SUBJECT: ADDENDUM No. 1

FILE: FHWTP Flocculation and Sedimentation Basins 1 & 8 Equipment Upgrade WT7093

**FLEMING HILL WATER TREATMENT PLANT FLOCCULATION AND
 SEDIMENTATION BASINS 1 & 8 EQUIPMENT UPGRADE PROJECT – WT7093**

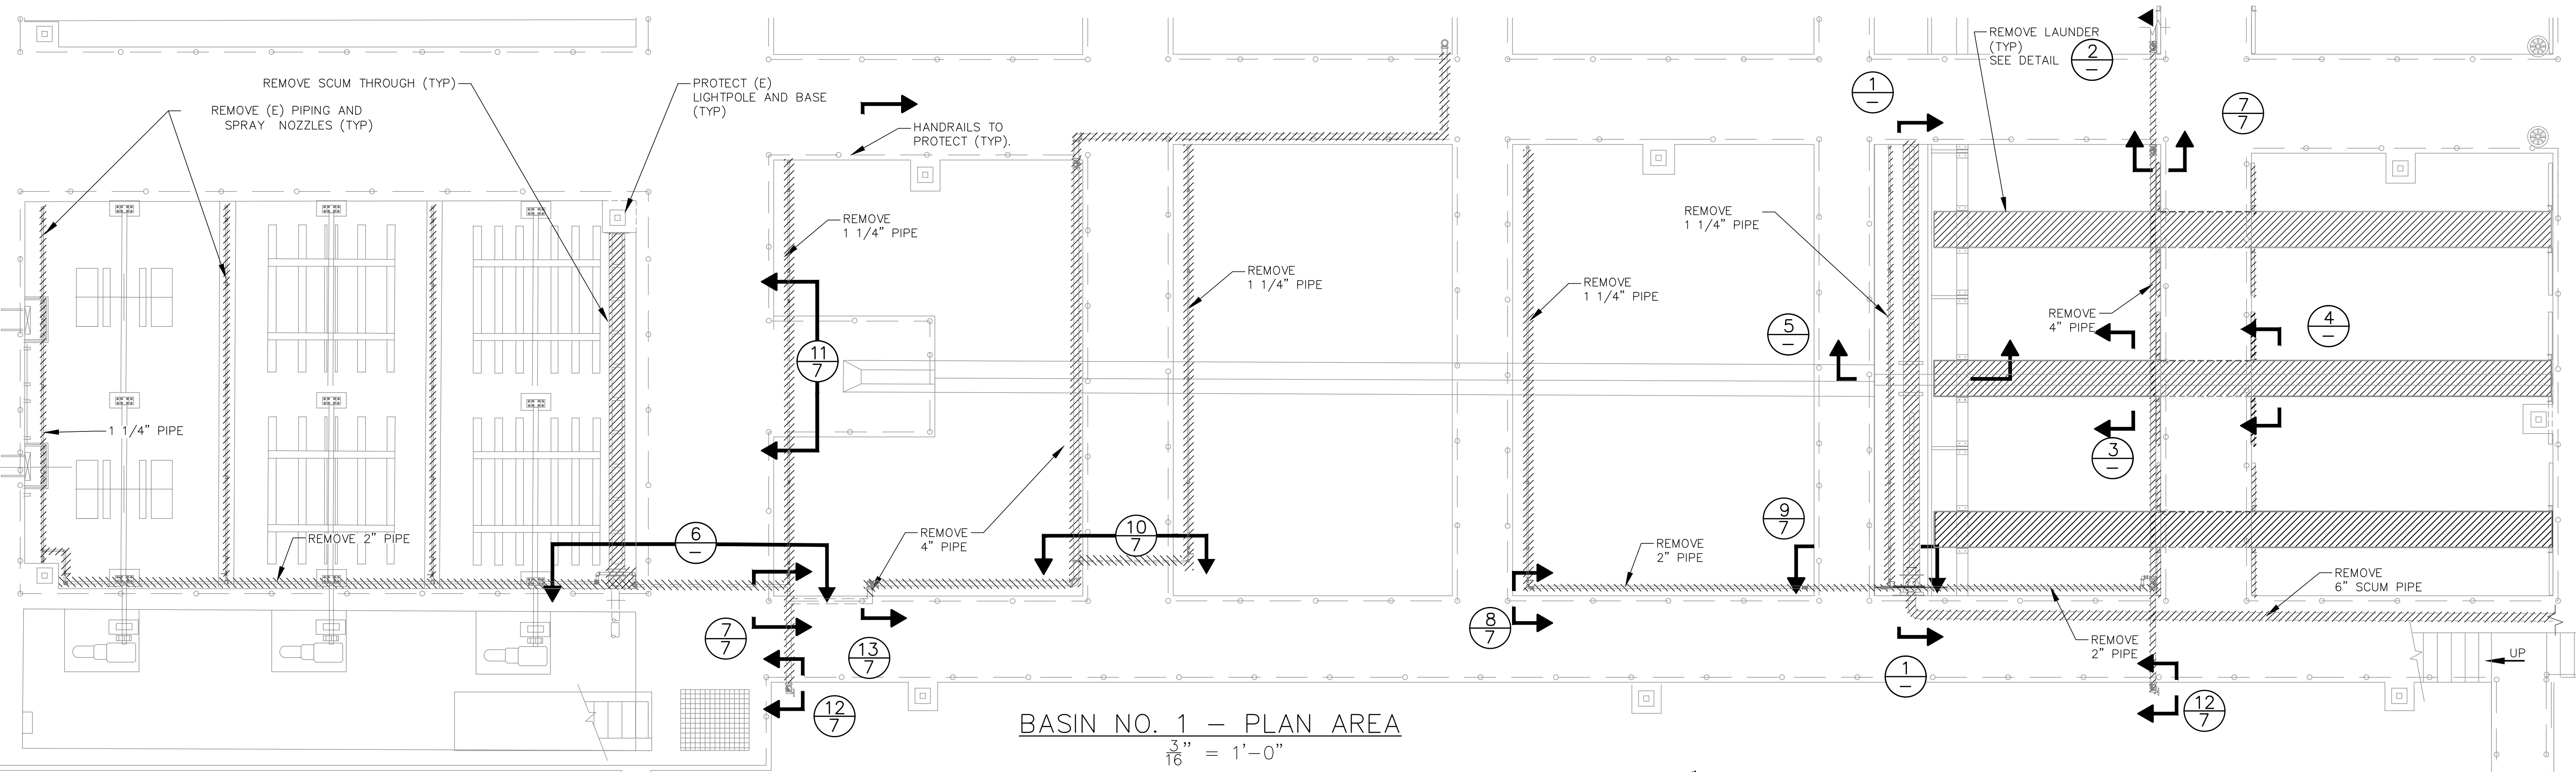
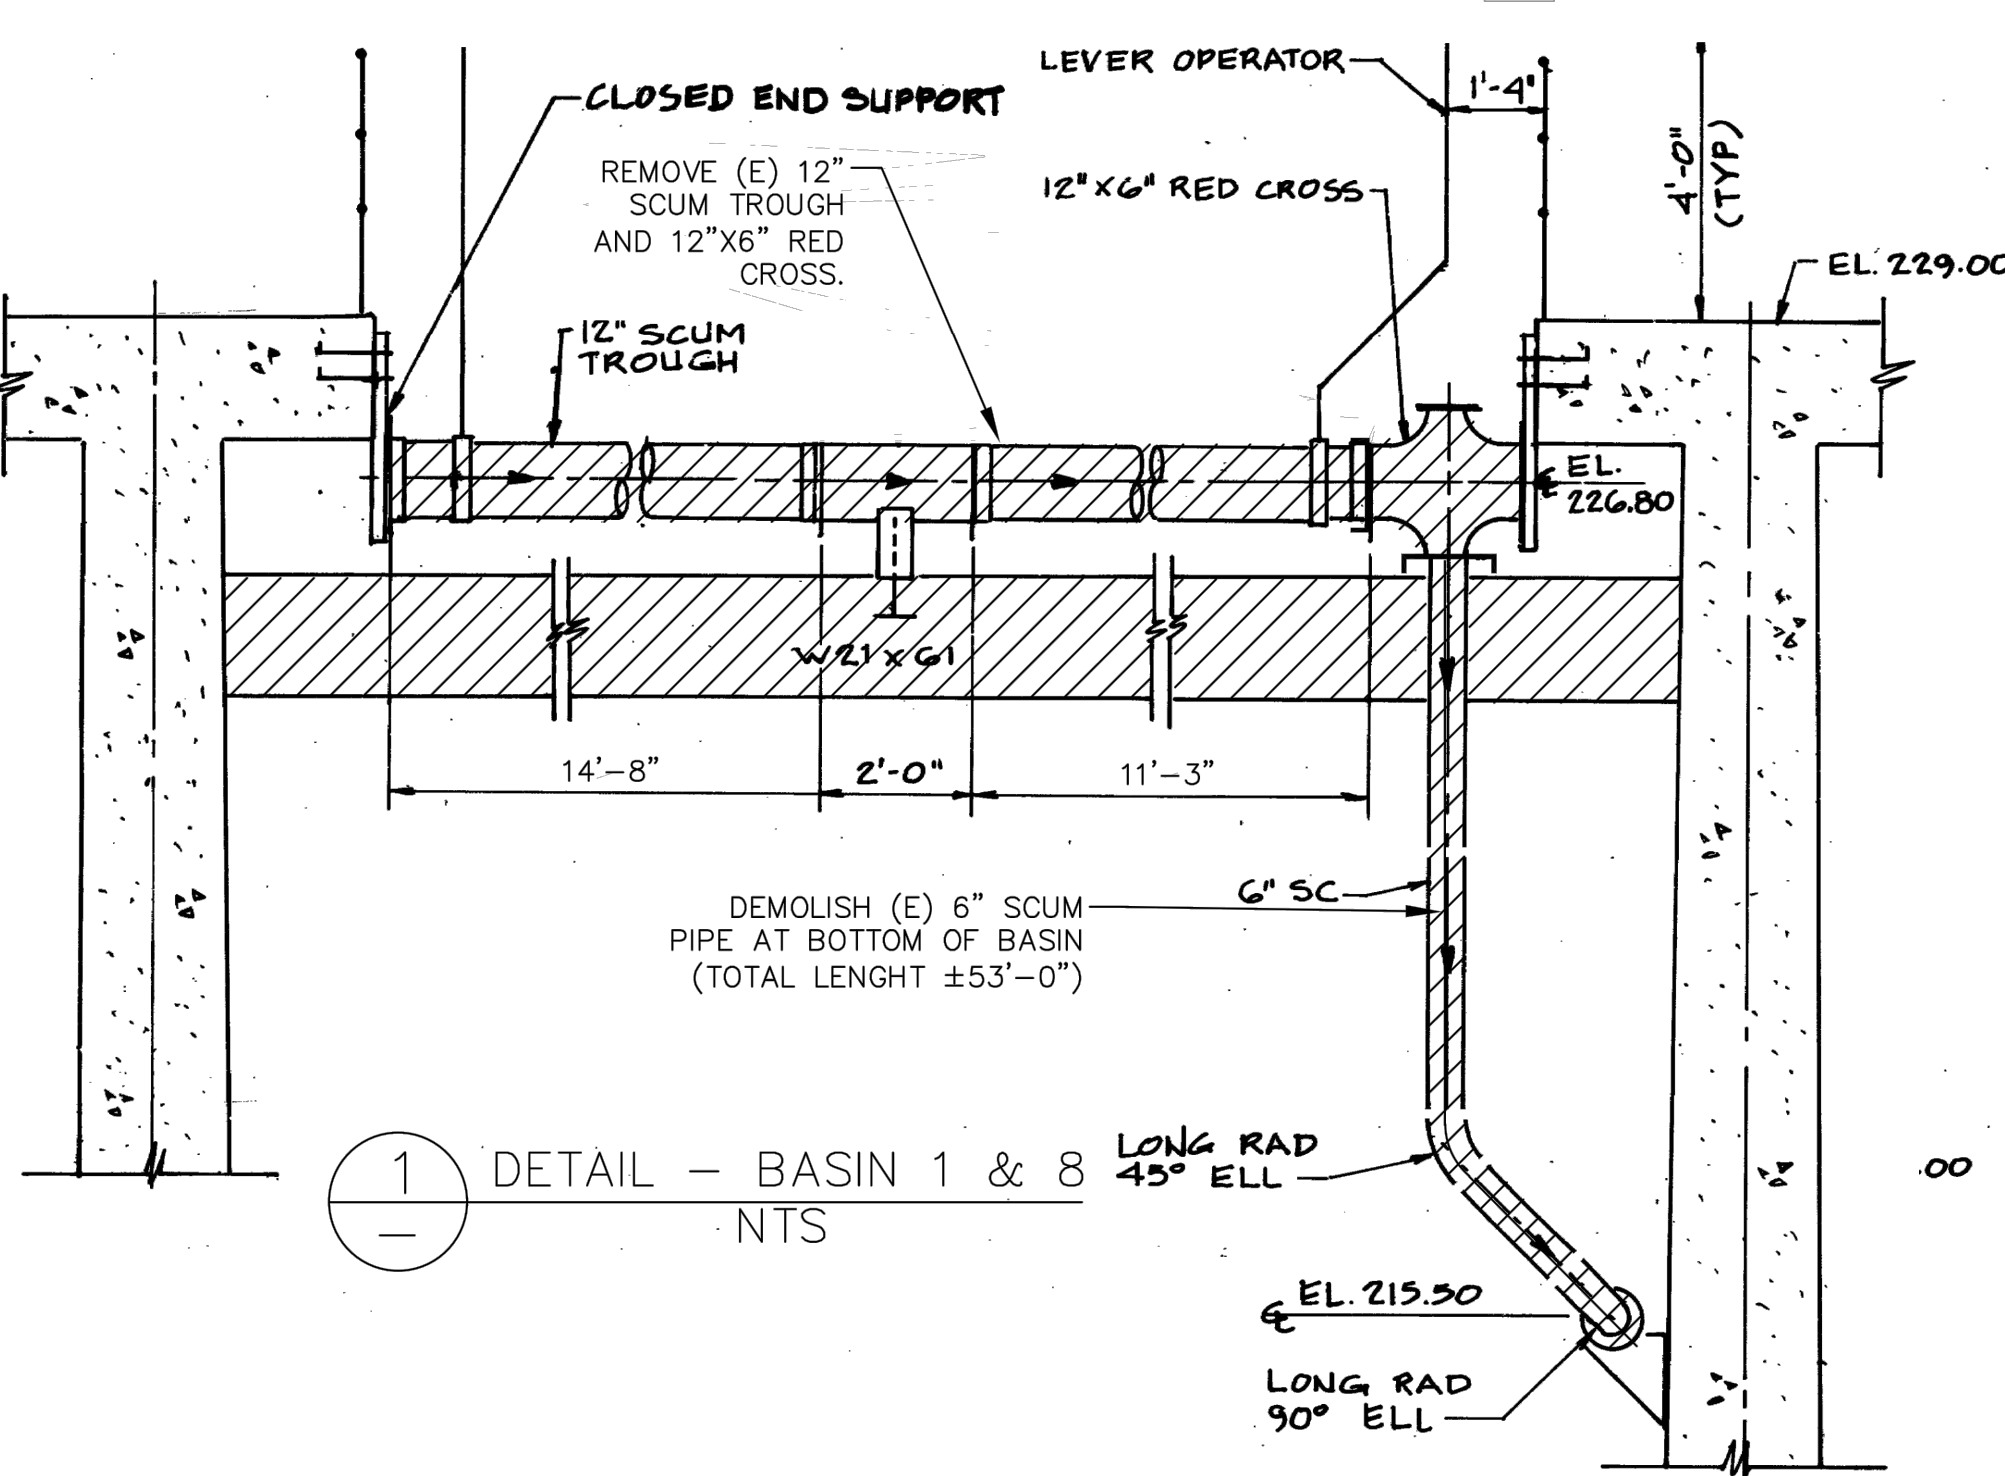
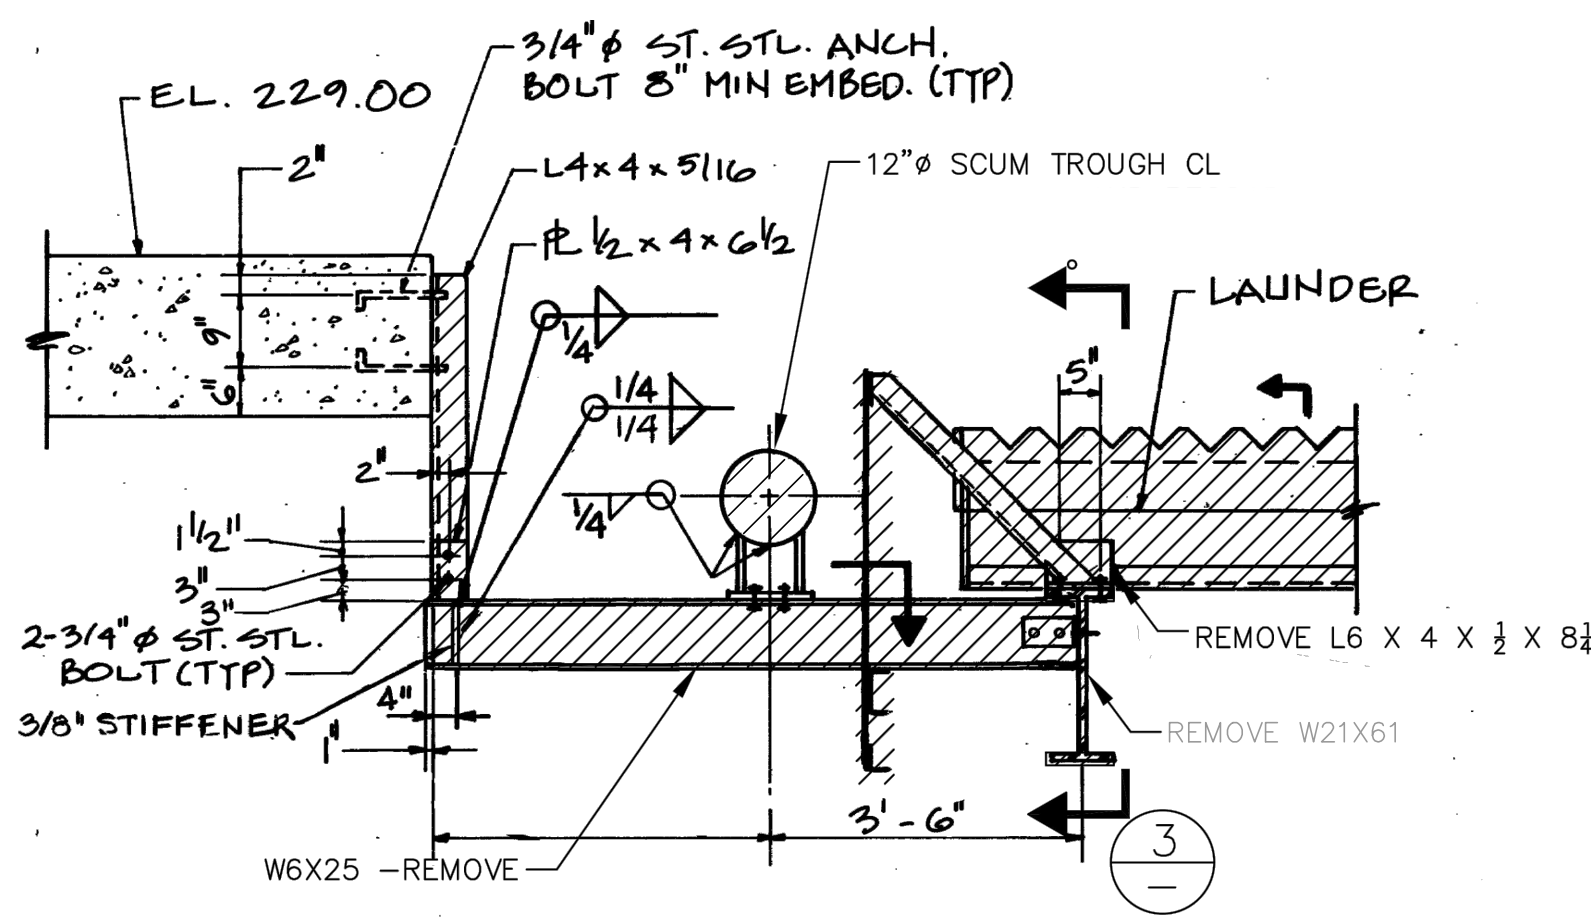
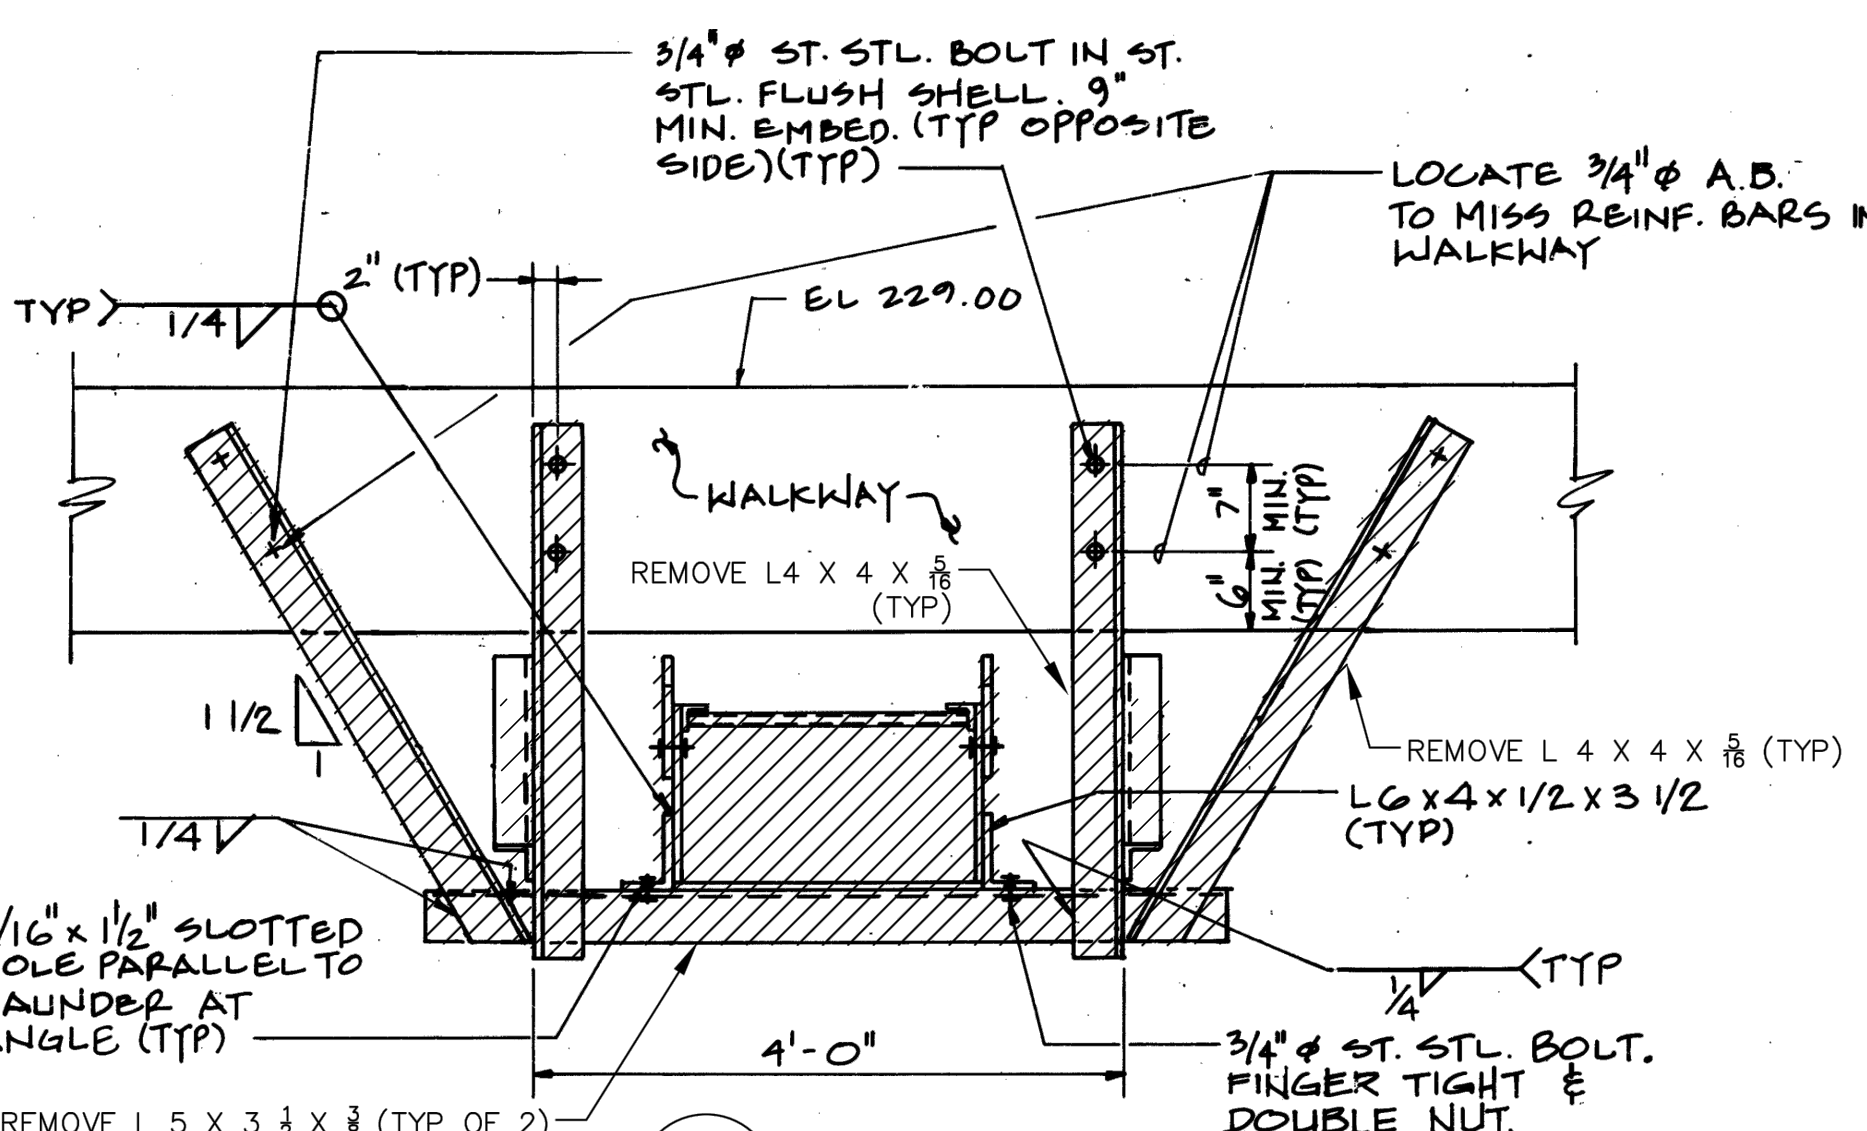
Sheet 6: Revised Notes.

- 11) Question: Sheet 6. Please confirm that the flocculation equipment is to be salvaged for the City (note 1) and the chain & flight equipment is to be disposed by the contractor (note 3).

- 12) Question: Sheet 6. In general, what hardware is being supplied by the launder and scum trough supplier?

- 13) Question: Sheet 6. Please refer to note 4 of the flocculator demo notes. Please describe the procedure for testing the concrete for soundness, pull out tests? For bidding purposes how many concrete pedestal/bases should we assume will be replaced? Or will these be replaced via change order.

Response: All of the equipment identified for removal shall be removed and be disposed of. Equipment that can be recycled shall be recycled as to meet the requirements of Section 02 42 13.

Response: The approved submittals for the launders and scum troughs are attached. The supplier will provide all of the supports for the launders except for the I-beams.

Response: Schmidt Hammer/Rebound Hammer procedure should be used for testing the concrete for soundness, no destructive testing. For bidding purposes assume no pedestal/bases will require replacement. A change order will be issued if repair or replacement of the pedestal is required.
